Issues in D1.1 State Diagrams

March 12, 2019

Figure 149-31 SEND_DATA and Figure 149-32 LINK_UP

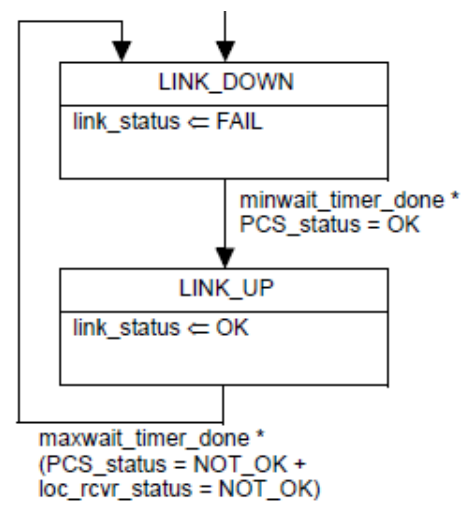
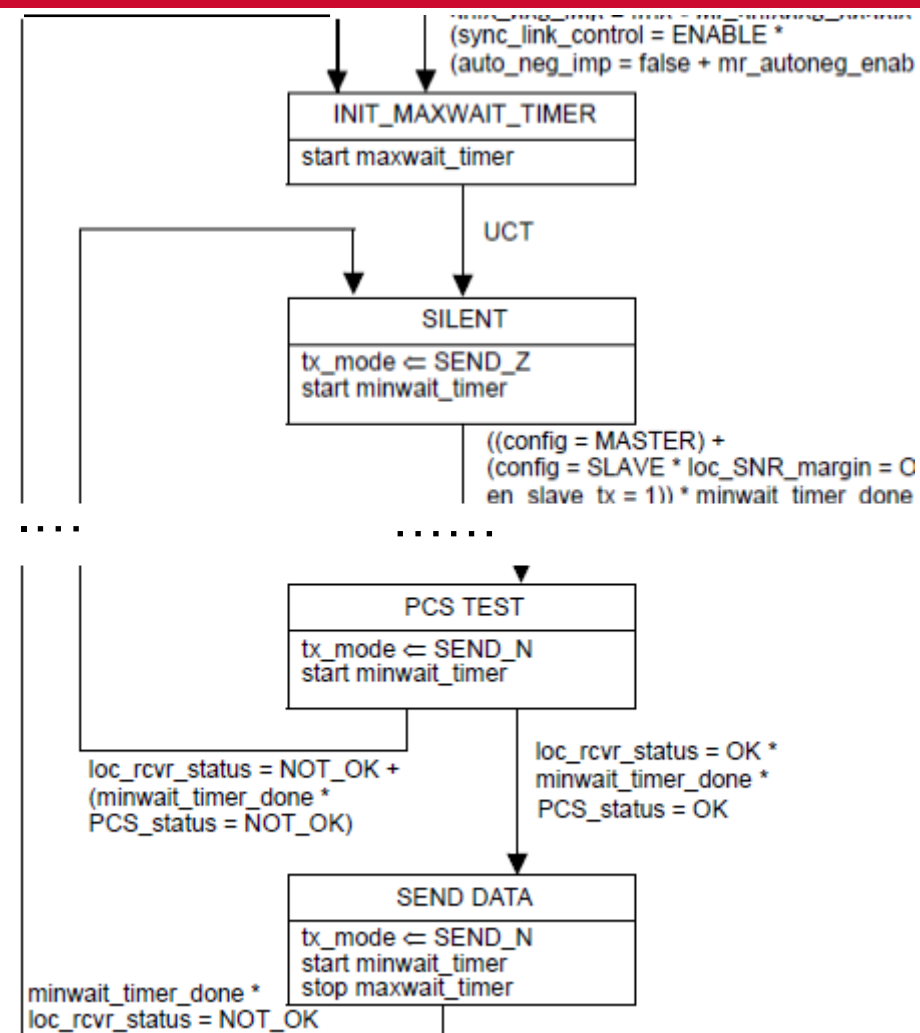
- PHYC enters SEND_DATA state, with maxwait timer not yet expired
 - maxwait_timer stopped
- Link monitor enters LINK_UP state
 - link_status <= OK
- Assume loc_rcvr_status drops when PHYC minwait_timer expires
 - PHYC exits SEND_DATA and goes to INIT_MAXWAIT_TIMER, then to SILENT
- Link monitor unable to exit LINK_UP state, as maxwait_timer already stopped, so never expires
 - link_status stays OK although PHYC went back to redo PAM2 training
- One work-around is to add the watchdog_status which monitors the line becoming SILENT
 - Add watchdog_status to the exit condition from the LINK_UP state, as shown in page 2 of [Lo 3ch 01 0319.pdf](#).

- Mike – at first, I thought you may have uncovered a VERY old problem on slide 2, that EVERY BASE-T PHY since 100BASE-T2 has carried forward (yes, the same relationship of maxwait_timer_done to the phy control and link monitor diagrams is present in 100BASE-T2, 1000BASE-T, 10GBASE-T, 2.5G/5GBASE-T, 25GBASE-T, 40GBASE-T, and 100BASE-T1).

- They all stop maxwait_timer upon reaching data (or idle) transmission, and they all rely on maxwait_timer_done as a condition going from link_up to link_fail. They all have an identical structure.

- Adding a 'watchdog' is not the way to fix this, if it is, in fact, a problem. Changing the maxwait_timer_done for something else on the link monitor might be better – IF anything needs to be done. I'm not sure it does, but I'm not entirely sure that it does. Here's what it looks like happens from the state diagrams (which doesn't agree with my memory):

- The maxwait timer will not be done when the phy successfully trains. Entry to the data (or idle) state stops maxwait_timer. If maxwait_timer_done is true, the PHY has failed to train. Link goes down, link fail inhibit dies with it.

- BUT, reading the state diagrams (again, I think implementations might be different) all of these phys, according to the state diagrams have hysteresis in their link state which seems to allow a retrain attempt. If the local receiver status drops to FAIL in the data or idle state will attempt a retrain, first resetting maxwait_timer (a "start timer" always resets the timer). They return to the training state in PHY control where maxwait_timer is started. In 802.3ch this is INIT_MAXWAIT_TIMER. If data mode is established without maxwait_timer expiring, no problem. Link stays up. If not, they drop link, and autoneg starts again.

- On the one hand, this seems to make sure you don't have to re-autoneg if you don't need it, but again, not sure this is what really happens - I would have thought link would drop.

- For issue #1 simply remove stop_maxwait_timer from the SEND DATA state. This is what is done in 1000BASE-T1.
- I'm ambivalent about the watchdog. I made a comment on that in case we want to adopt it but I'm also ok not having it.
- For issue #2 I think we can redefine PCS_status by adding one more condition and that is the PCS datapath is decoding properly.
- I don't like the solution to set hi_rfer to default to true since it may have other side effects like setting registers.
